Customer Information Bulletin

Subject: Launch of printer firmware 1.0.4-1.

Figure 4® Modular

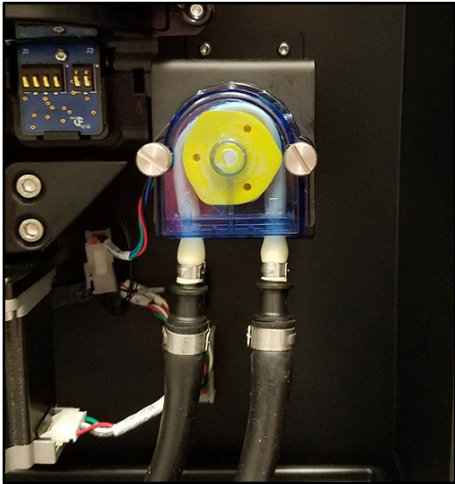
Firmware 1.0.4-1 has been launched. This firmware change will allow the printer to accept a new type of material pump when a replacement is needed.

CAUTION: ONLY DOWNLOAD THIS FIRMWARE UPDATE IF YOU HAVE THE NEWEST PUMP (ABOVE, RIGHT).

If you do not already have the new pump, contact 3D Systems Service to determine your needs.

If you do have the new pump, 3D Systems Service should have given you the new firmware file, as well as a procedure to install the pump and the firmware. Also, the new pump will require a new Material Changeover (MCO) Kit. The new MCO procedure can be found in the [updated User Guide](#).
